**CORRO-CONSULTA**

**MEMORANDUM – REDACTED VERSION – JULY 19, 2007**

**Subject: Update of Current Knowledge Regarding the State of Integrity of OCNGS Drywell Liner and Comments Pertaining to Aging Management Thereof**

Figure 2

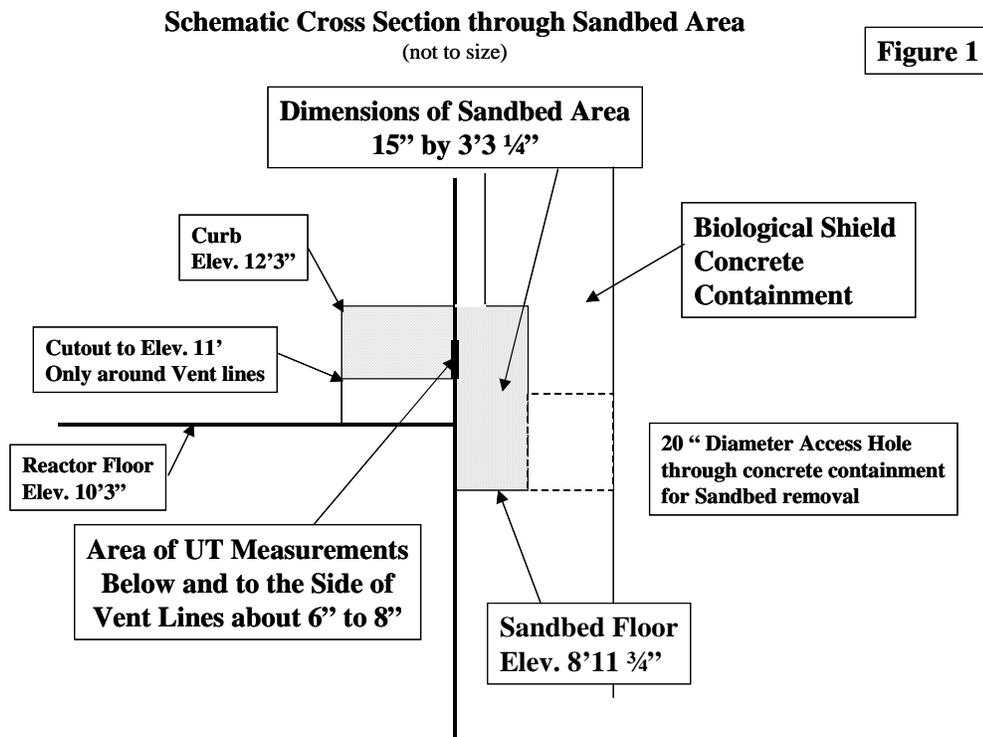
We take issue with this statement. In support of this contention, an effort was made to show graphically the remaining wall thickness observed in all of these various locations. Thus Figure 2 shows, by way of example, the remaining wall thickness from the 2006 UT measurements made with the help of 6 by 6 inch grids as a function of elevation in the **trench of Bay 17**. It is understood, as is described in Ref. 3 that 6 such grids were placed one on top of the other in the trench in order to capture the corrosion from the bottom to the top of the sandbed. Hence, if the bottom of the trench had the elevation about 9 feet, then the top of the 6 grids would have had an elevation of about 12 feet, which according to Figure 1 corresponds to the top of the sandbed and is at least 9 inches higher than the top of the grid used for UT measurements from the inside. (Note, none of these elevations is terribly accurate, however, the top of the trench measurements were definitely lower (deeper pits) by a good margin than the inside grid measurements). Figure 2 plots all individual 2006 measurements from the trench in bay 17. The 6 traces represent the variation of the wall thickness in the horizontal direction while the traces themselves extend from the bottom of the trench (left hand side) to the top of the trench (right hand side). The

undulations of the 6 traces, which are at times (at the same elevation) in synch and at other times out of phase clearly depict the nature of the “golf ball type” surface described in AmerGen literature (Ref. 1 pg. 4). Where the undulations are in synch one can estimate that the extent of the pit at that location extends over an area larger than just one inch in diameter<sup>3)</sup>. It should also be noted that the average amplitude of the undulations in Fig. 2 are of the order of 0.1 inch, i.e. the roughness of the surface at this point is only of that order of magnitude. AmerGen estimated the “roughness” of the surface to be rather of the order of 0.2 inches (Ref. 5 pg. 5).

The most striking observation is that the corrosion is most severe at the top, almost uniform in severity over most of the depth of the sandbed and again somewhat more severe at the very bottom.

Figure 3

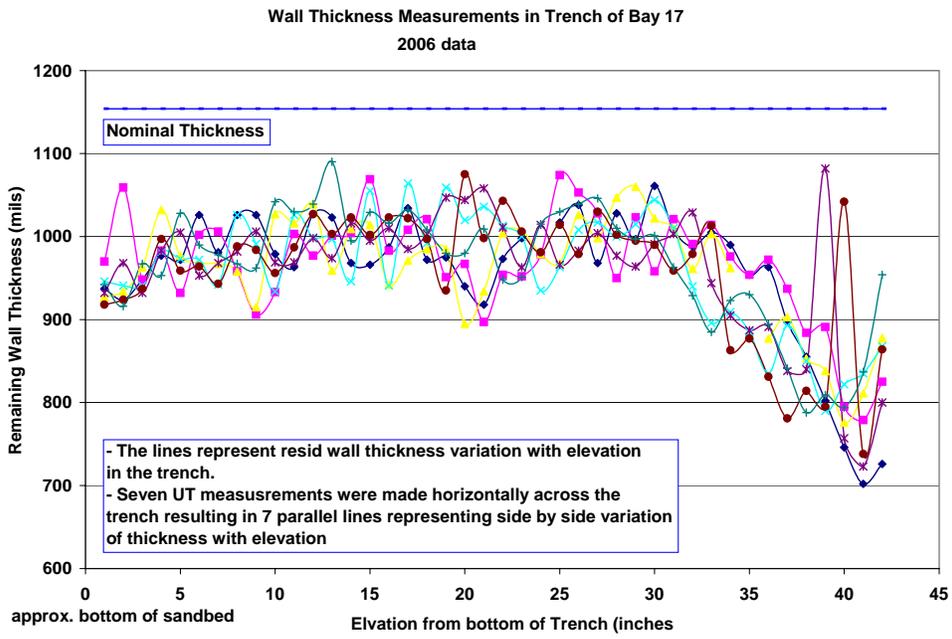
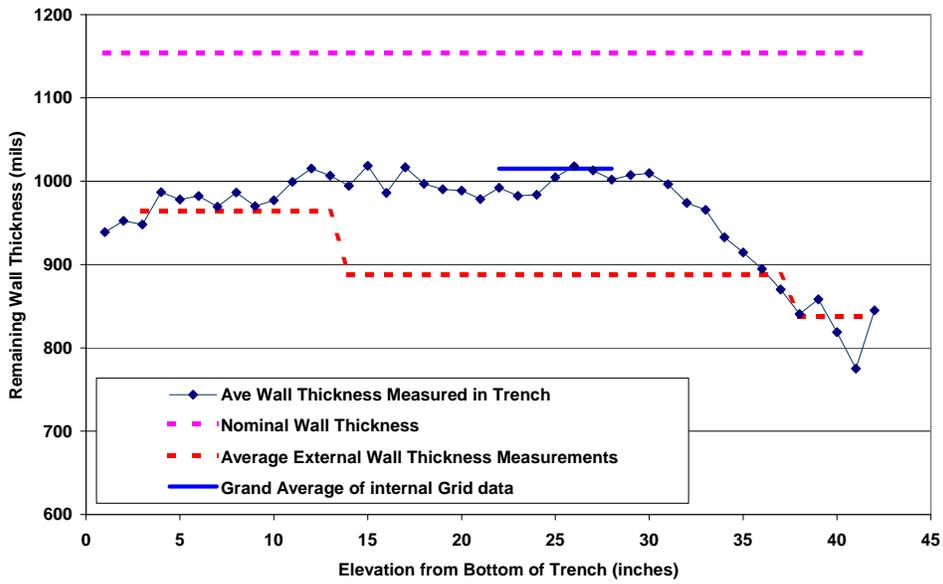
In Figure 3 an effort is being made to compare the average remaining wall thickness from trench measurements (averaged over the horizontal direction) with the average of the 6 by 6 grid measurement from the inside and the direct UT measurements from the outside. Also graphed in this figure are the averages of the outside measurements for the three zones for which data are reported (Ref. 5). What one can see is that the averages for the grid and the trench data overlap quite well at the same elevation. However, the average outside measurements are significantly lower at comparable elevations.<sup>4)</sup> This is probably because the choice of location for the external measurements was deliberately biased towards thin spots.

Figure 4

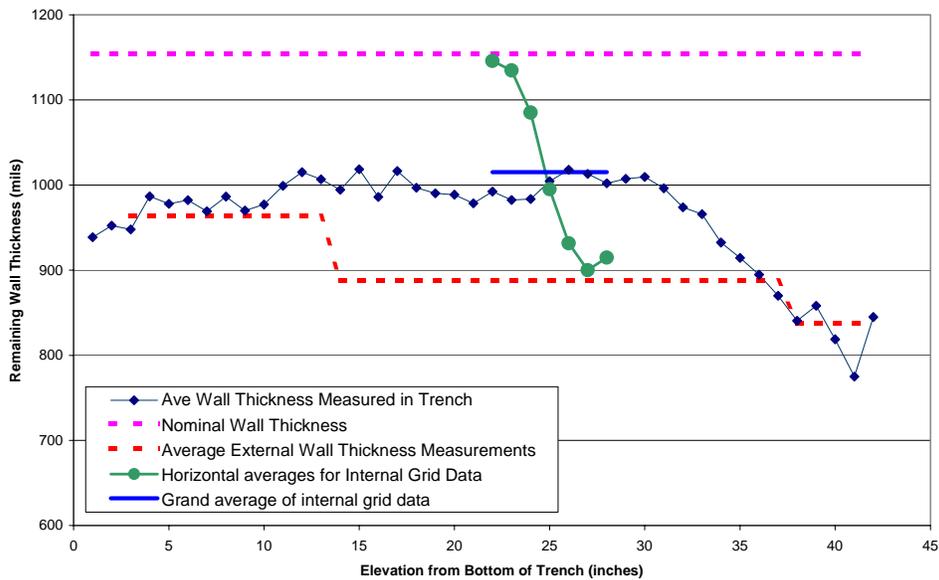
Finally in Figure 4 we see the spread of the 6 by 6 inch inside grid measurements superimposed on the averages of the other measurements.

**Conclusion: What the superposition of the UT measurements in Bay 17 demonstrates is that wall loss ranges from zero to 33 percent, however, only the trench and outside measurements come close to represent the most severe corrosion at the highest elevations. It should also be remembered that the grid measurements at the inside curb cutout as well as those in the trench are only 6 inches wide. One does not have, therefore any indications as to how far serious corrosion may have spread laterally around the circumference of the bay.**

Figure 5

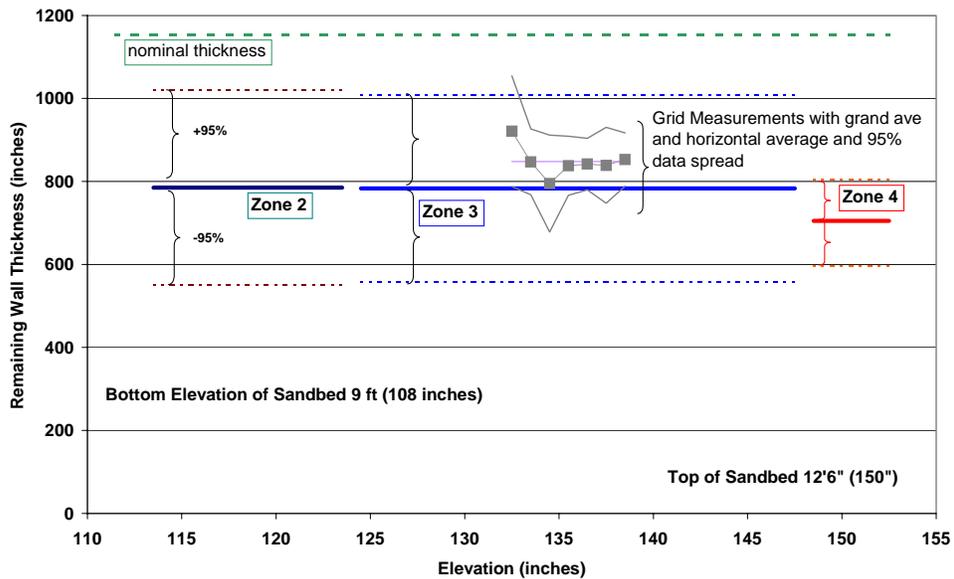
Figure 5 shows an analysis of the available 2006 data for Bay 13. Bay 13 is probably the second worst corroded bay apart from Bay 1. The averages for the external measurements for each zone are fairly similar, as are the 95% limits for the data spread. There is a 95% percent probability for the deepest penetration to be of the order of 48% of the original wall thickness. The superposition of the internal grid data shows a higher average and a narrower distribution of the data spread. Again one recognizes that the internal 6 by 6 inch grid measurements do not represent the worst corrosion degradation.

Figure 6

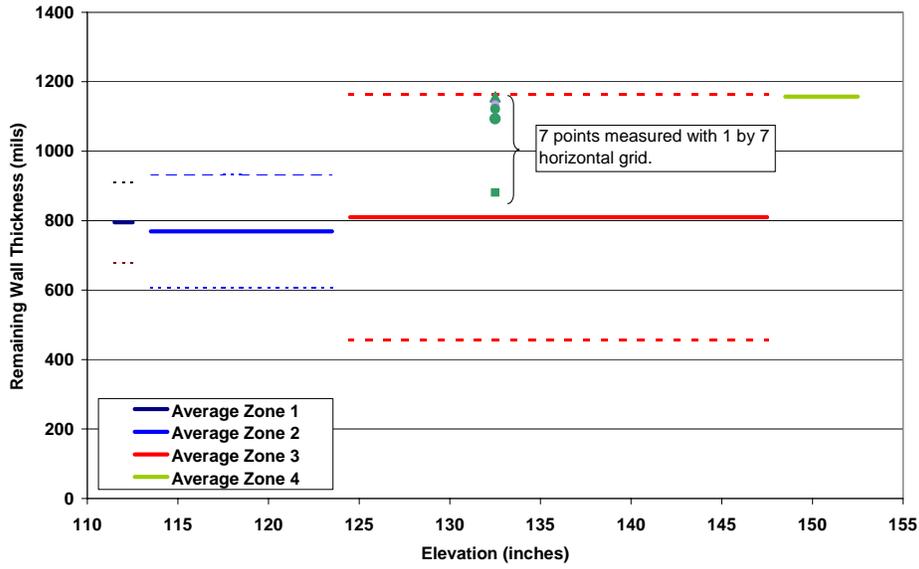
Finally in Figure 6 we show the distribution of the external measurements for Bay 1. One observes that the 95% lower limit of the data spread is around 40% of the original wall thickness, or indeed at a remaining wall thickness of 450 mils, which is 0.04 inches below the required sandbed thickness for the Design Pressure and Temperature. Because the external sampling in Bay 1 was designed to capture the thinnest points, this is a conservative estimate of the minimum wall thickness. However, given the need for a very high degree of confidence that the drywell shell is ready to withstand accident pressures and the uncertainty created by the sparse data set, I believe that a conservative approach is required in this case.

Figure 7

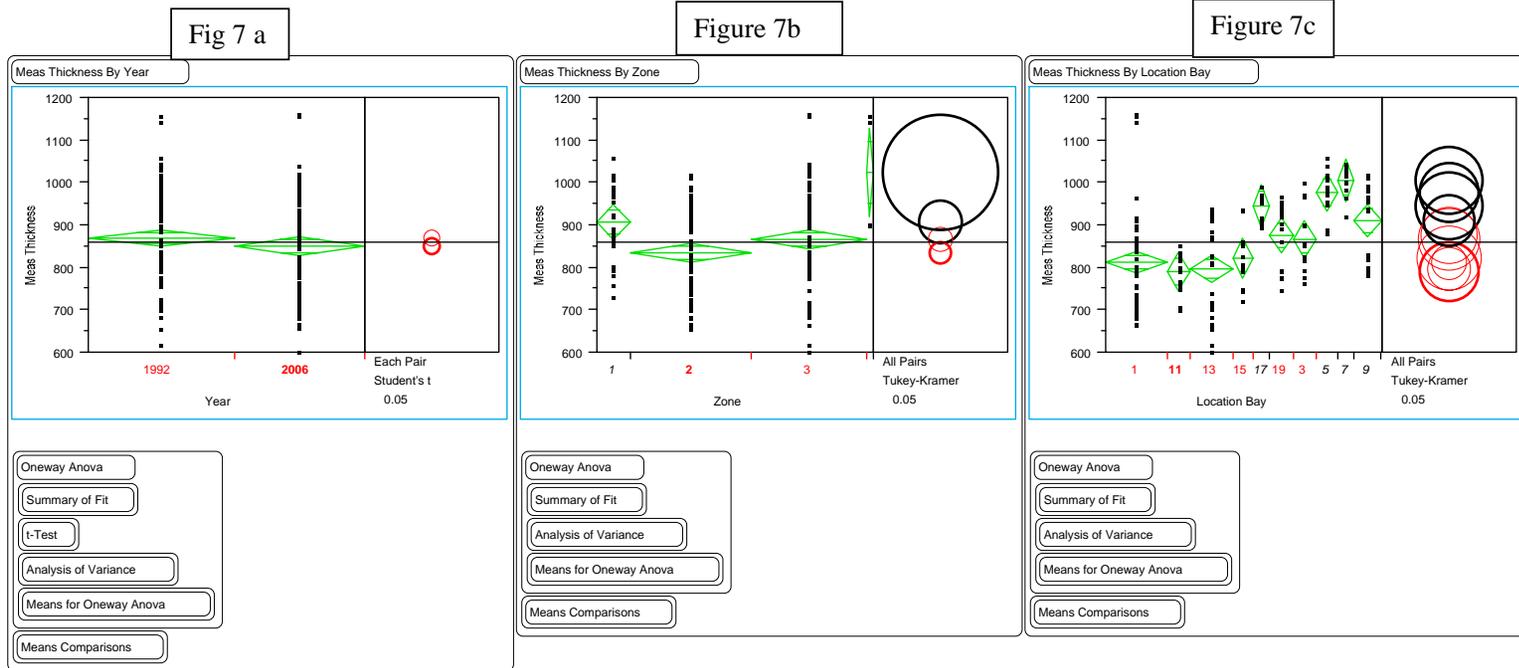
It was found that there is no significant effect of the time (Fig.7a). While there is a decrease of 19 mils between 1992 and 2006, this difference is not statistically significant within the variability of the data. The differences between the zones, however are significant. Zone 2 is by far the most corrosive zone. When the bays are compared, one finds as expected that some bays have experienced little corrosion in contrast to others. The importance of these observations is obvious: they point again to the fact that the intensity of corrosion is a clear function of elevation and bay. Hence, averaging data and generalization may lead to doubtful conclusions.

Comments: Figure 7a: Comparison between measurements I 1992 and 2006 show no significant difference. The means from 1992 and 2006 show a bias of 0.018 inches, but the bias is statistically not significant despite of the many data points. Fig. 7b: The comparison between the “zones” (elevations) is significant. Zones 1 is significantly different from zones 2 and 3. For zone 4 there are not enough data for statistical significance. Fig. 7c: Some bays, red ones, are significantly different from the black ones.

**Figure 8: External UT Measurements in Bay 15**

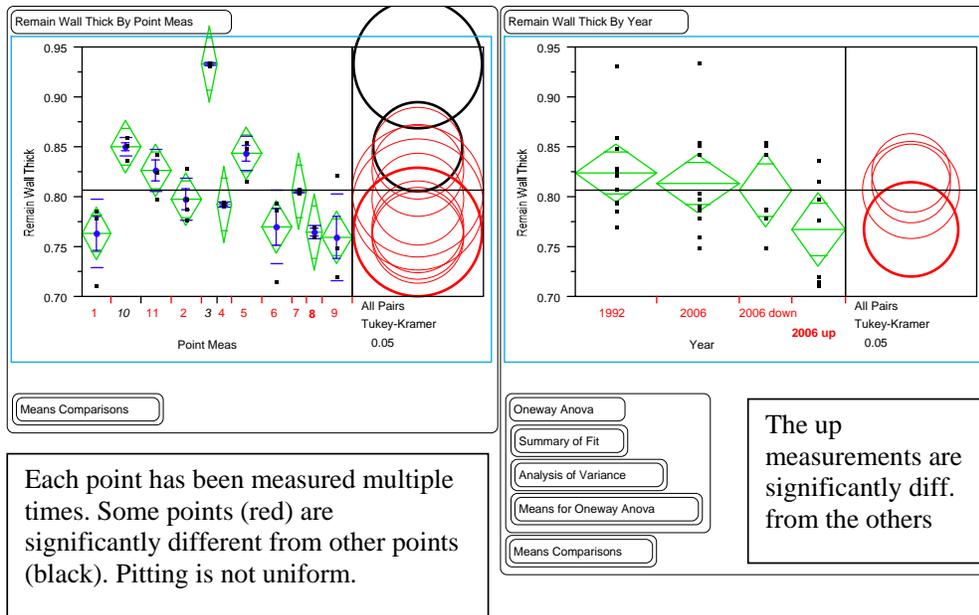
In 2006 the validity of some of the external UT measurements was explored by measuring around the nominal original locations. These data were statistically evaluated in Figures 8, 9, 10 for Bays 15, 1 and Bay 19. The additional data collected in Bays 19 and 15 had been identified as “up” or “down”, hence additional data sets

identified as 2006 up and 2006 down were compared with the original 2006 data. It turns out for Bay 19 for instance that the UT penetrations identified as 2006 up were significantly lower than the measurements of 1992 with a probability of better than 95%. The difference between the 1992 and 2006 up data is 0.1 inch. Similarly for Bay 15 one finds that the 2006 up data are significantly lower than the original 1992 data by about 0.06 inches, although this difference is not significant at the 5% level. For Bay 1 there is practically no difference between the 2006 and the 1992 data sets, because of the two or three measurements in the non-corroded areas. Summarizing these results in Table 1, one finds that the lower 95% confidence limits for Bays 1, 15 are marginally within the 0.736-inch limit. Since one does not know exactly how extensive the “cancer of corrosion” in the sand bed area really is, it is very difficult to put this interpretation in perspective with the assessments made by AmerGen relative to areal criteria for thinned areas (see discussion below).

**Figure 10: External UT measurements in Bay 19**

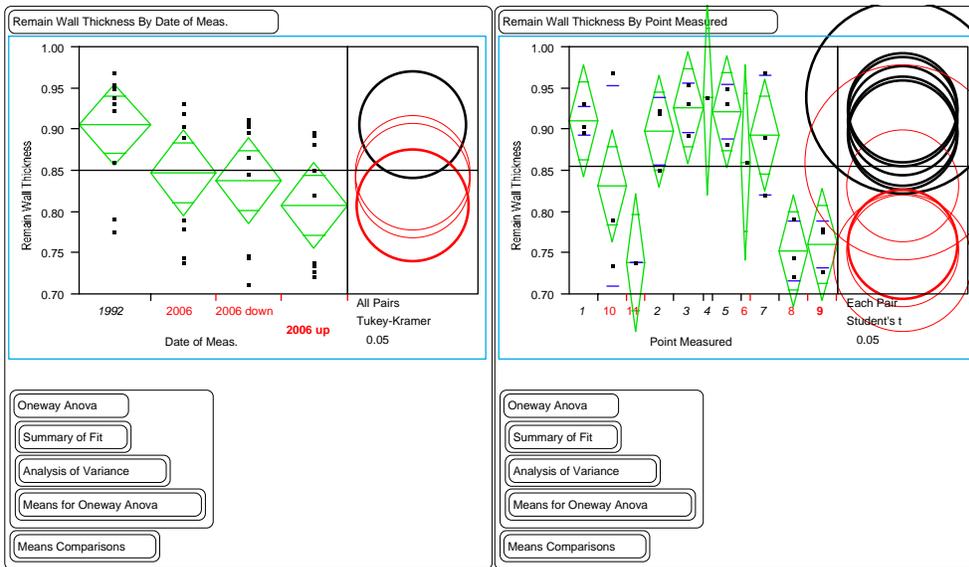
Again one finds that the “up” measurements are significantly lower from the 1992 measurements.
